ADDENDUM NO. 2

August 7, 2026

Perry Township Schools:
Southport High School Addition & Renovation Phase 2 (Classroom Addition and Athletic Renovations)
971 E. Banta Road
Indianapolis, IN 46227

Phase 2: ADDENDUM NO. 2 (TWO)

Southport High School Phase 2 Site Logistics Plan

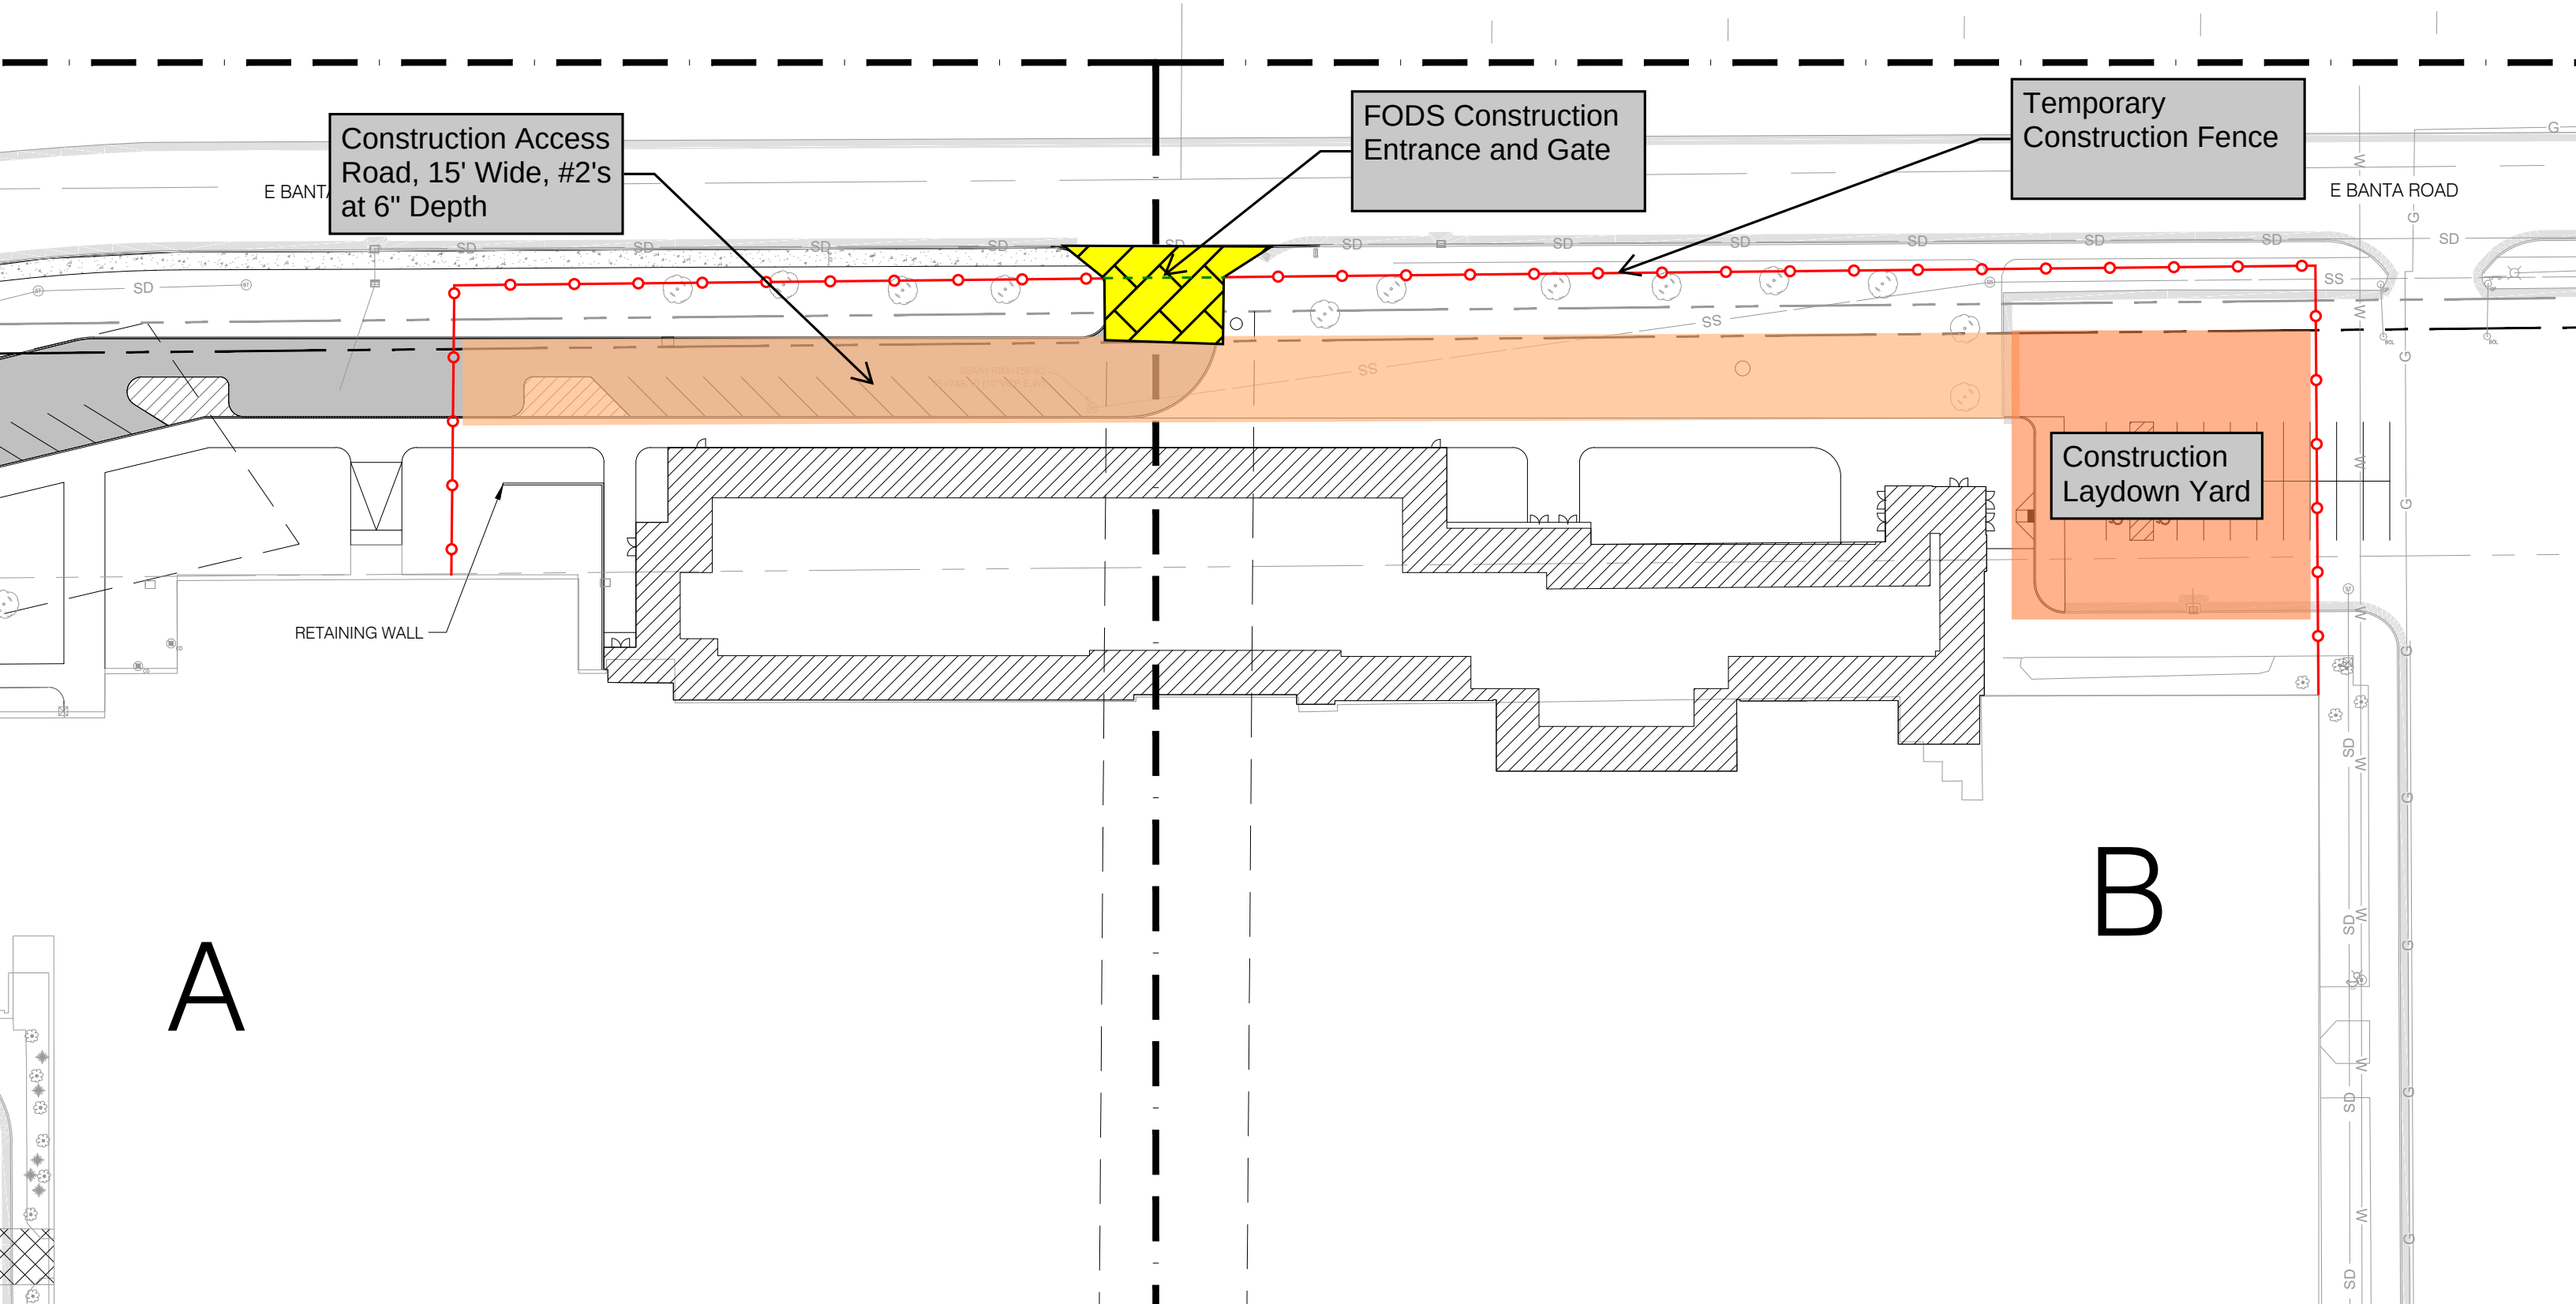
01 32 00d Site Logistics Plan with the revised Site Logistics Plan

EXTERIOR ELEVATIONS

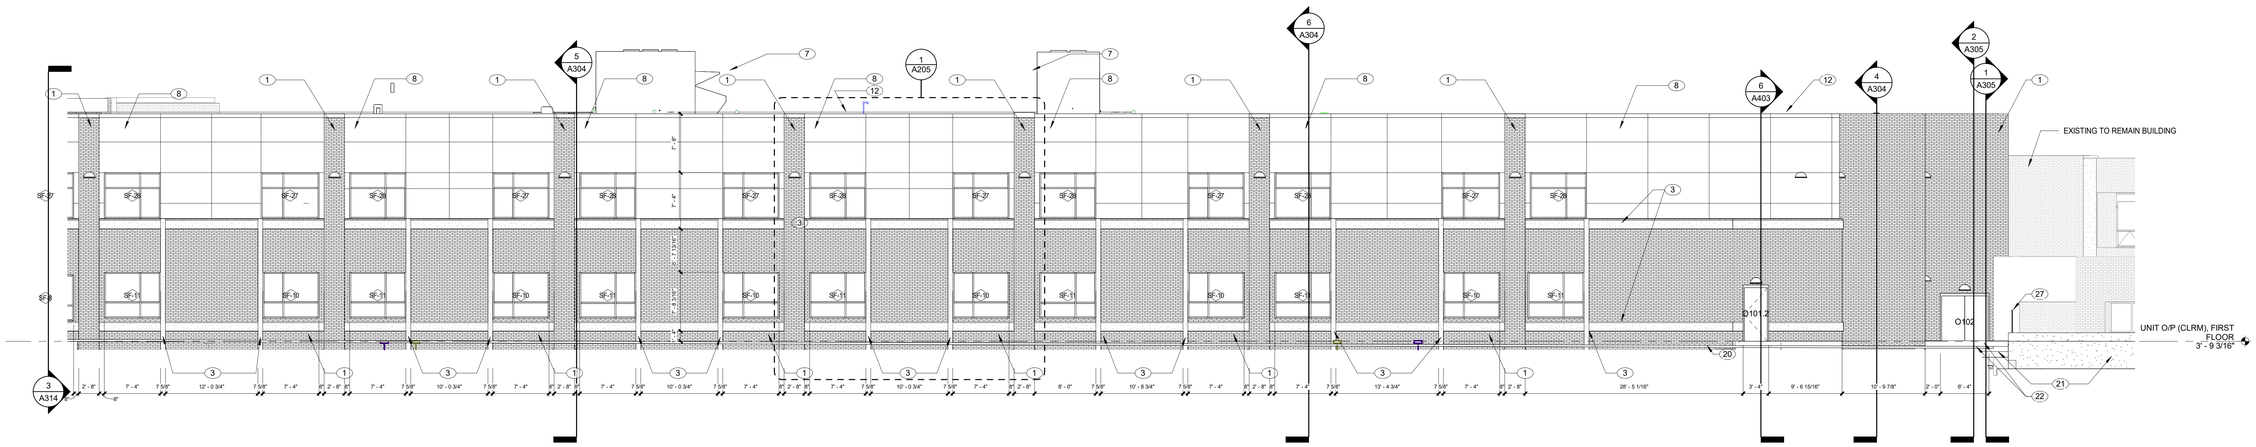
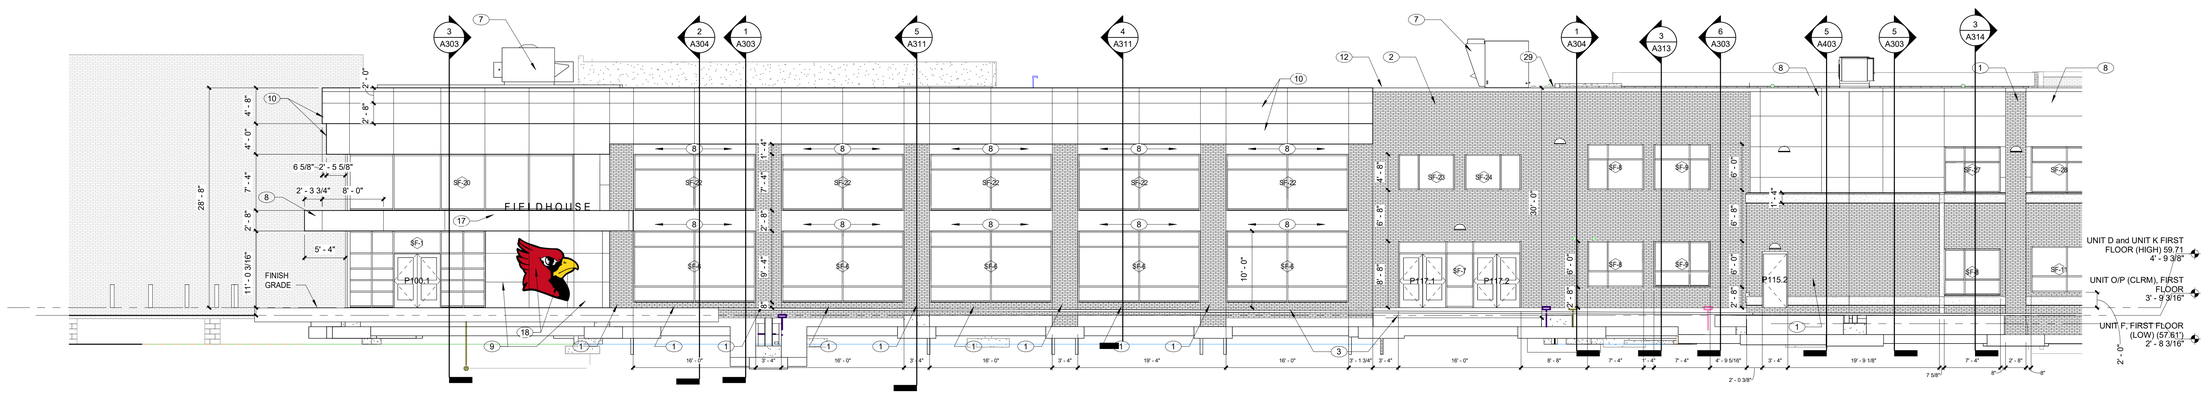
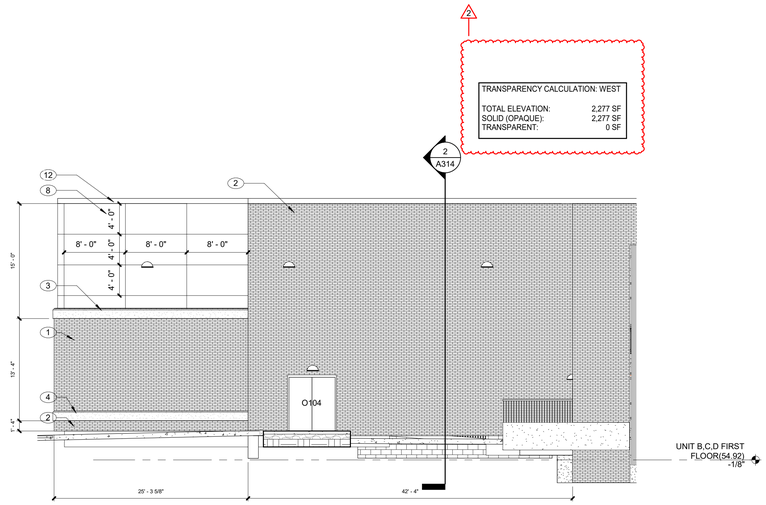
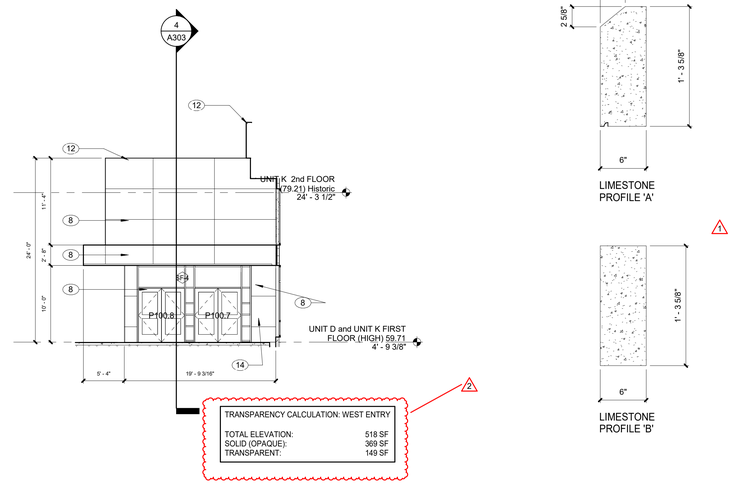
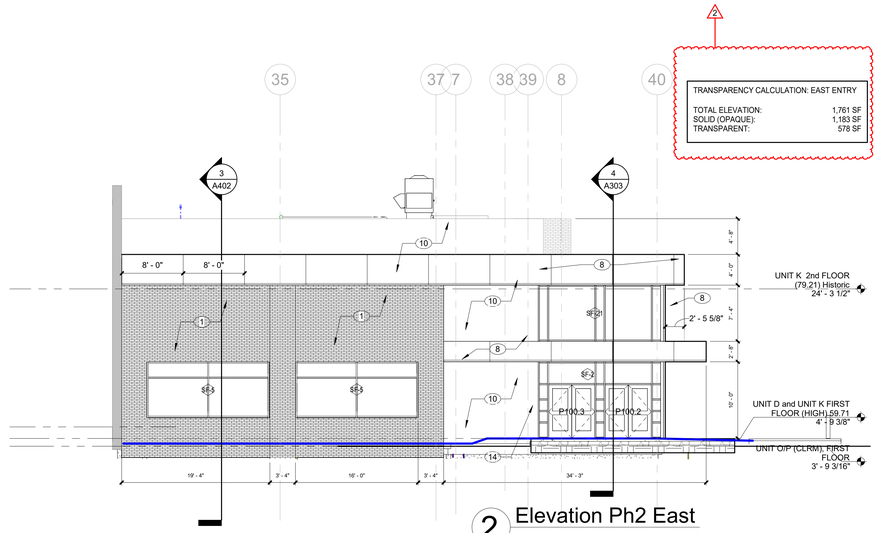
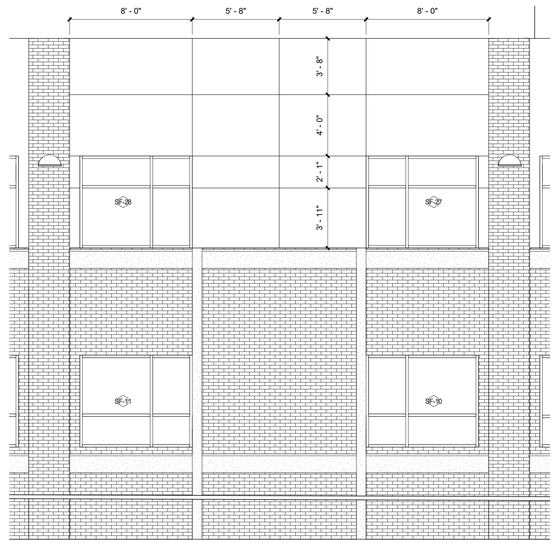
11. Drawing Sheet Number : A205
    Drawing Sheet Title: EXTERIOR ELEVATIONS

EXTERIOR ELEVATIONS, COURTYARD

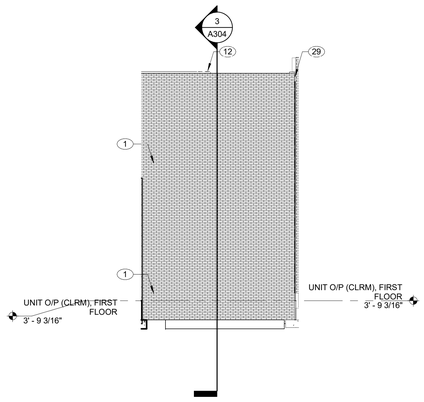
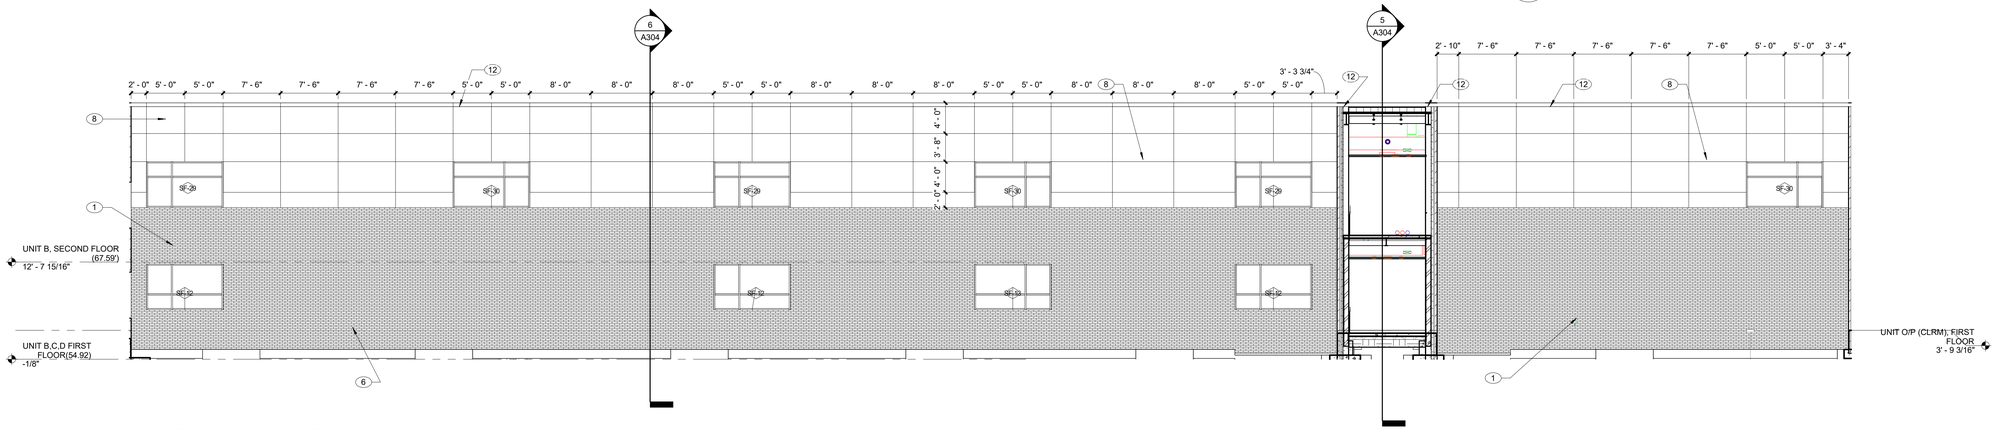
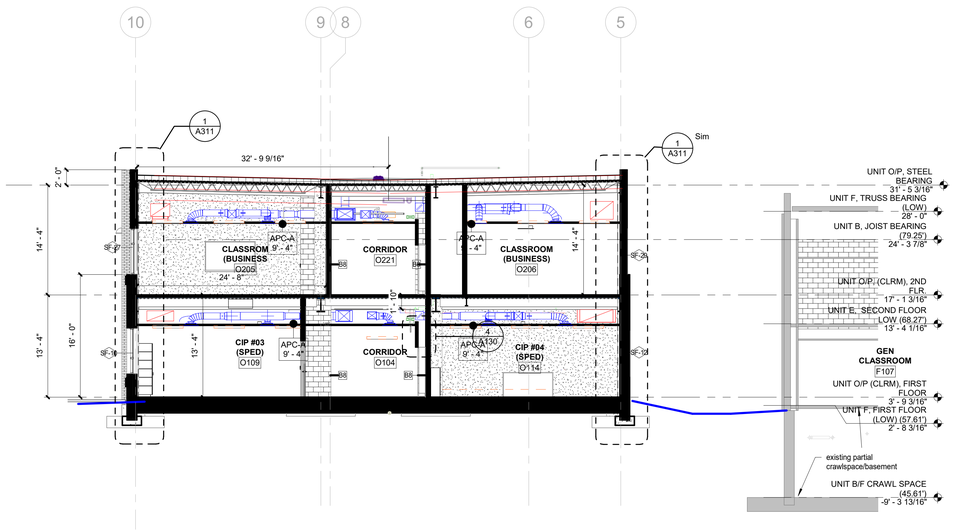
12. Drawing Sheet Number : A206
    Drawing Sheet Title: EXTERIOR ELEVATIONS

Change:
    - Add transparency calculations per City of Indy drawing requirements.
    - Add keynotes to elevation 6 and 7.

BUILDING SECTIONS

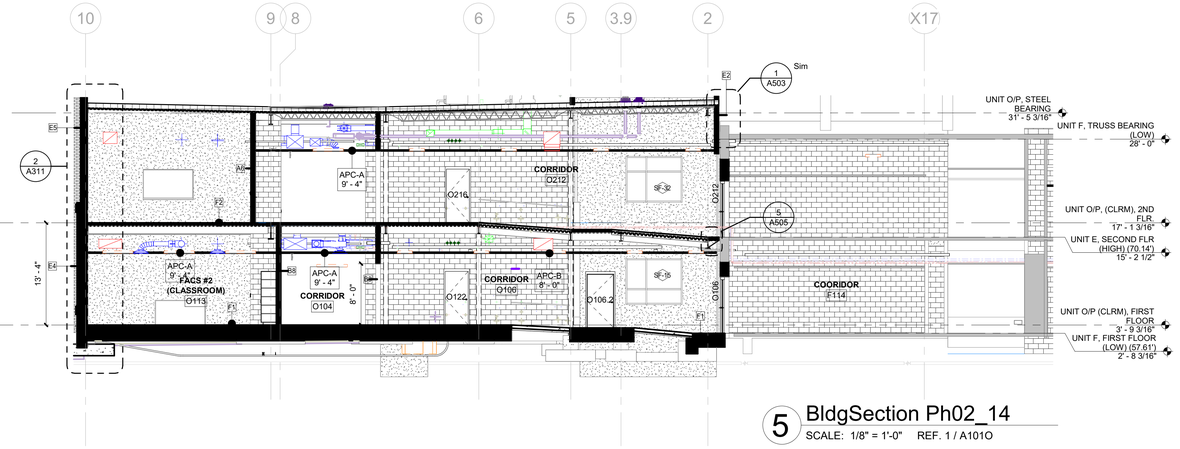
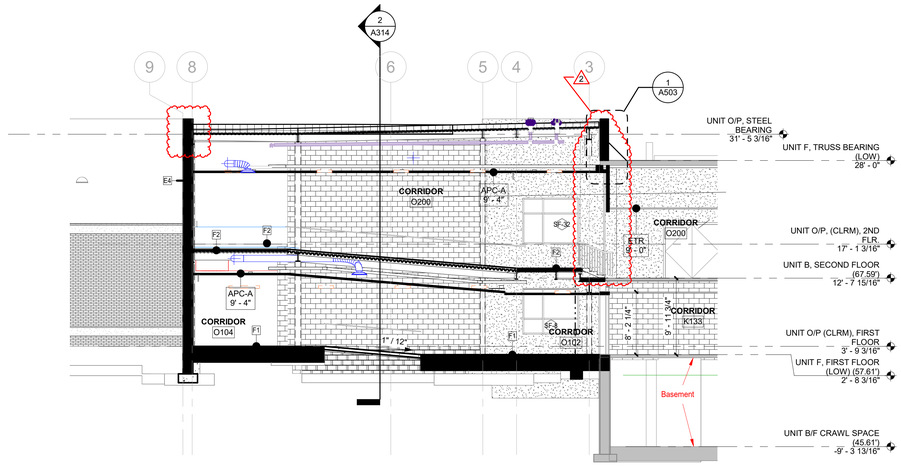
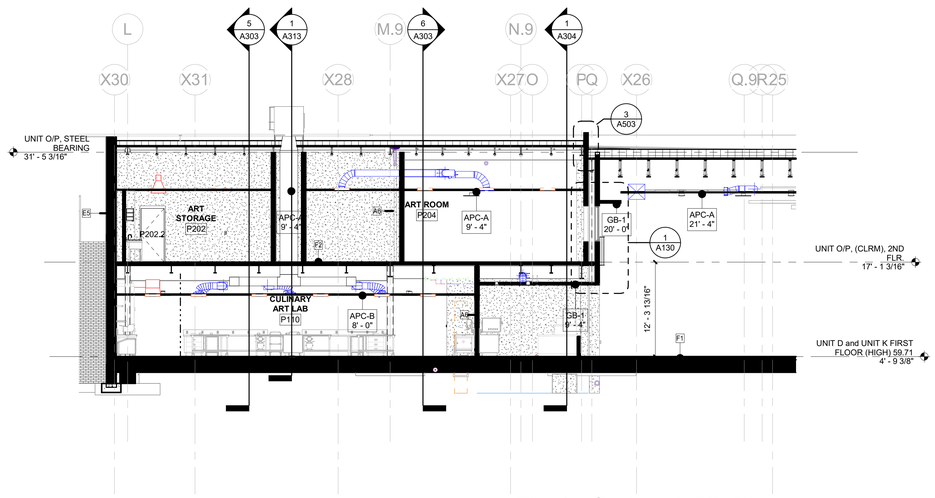
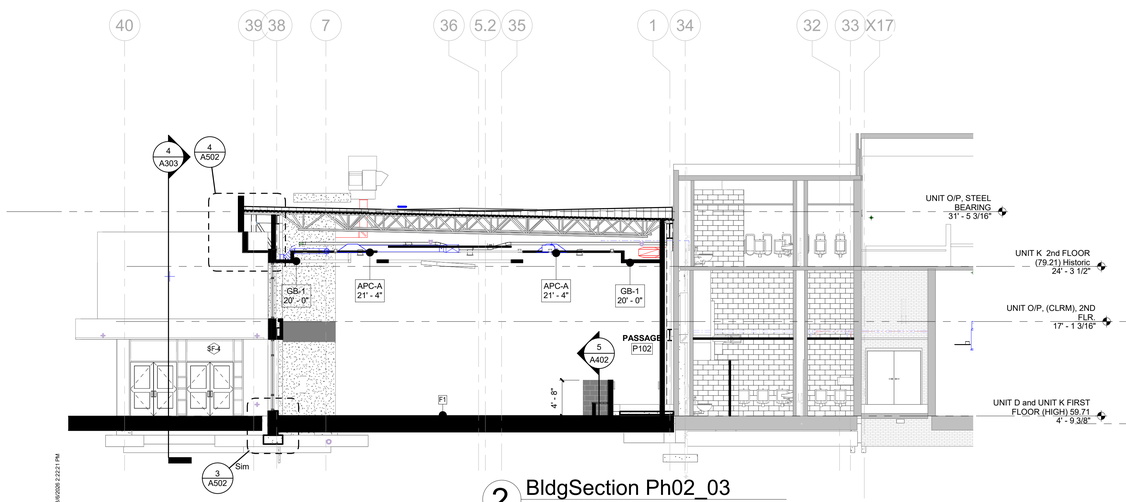
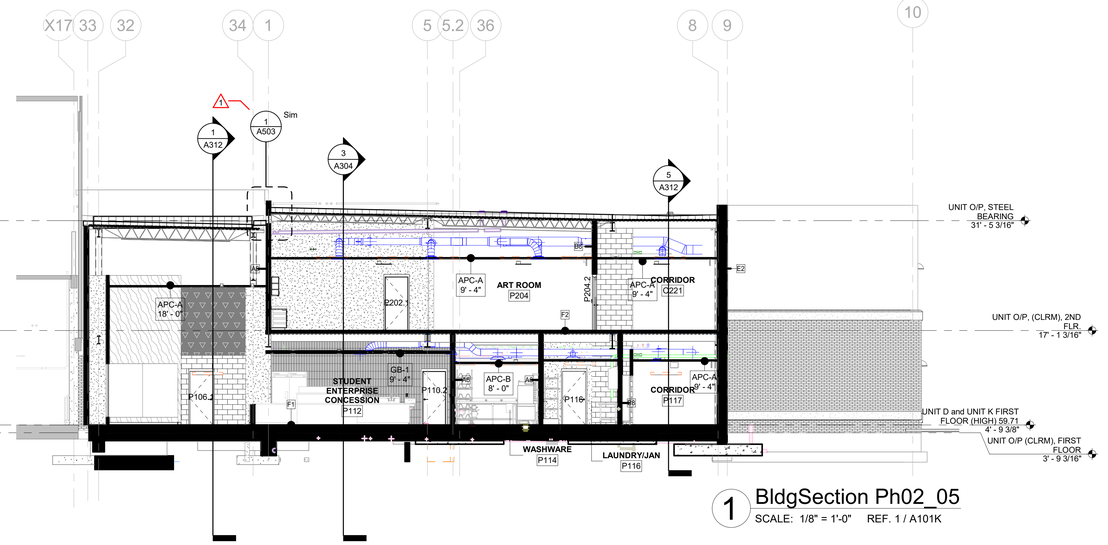
13. Drawing Sheet Number: A304
    Drawing Sheet Title: BUILDING SECTION

Change:
    - Modify location of steps.
    - Add bulkhead wall between new and existing ceiling.
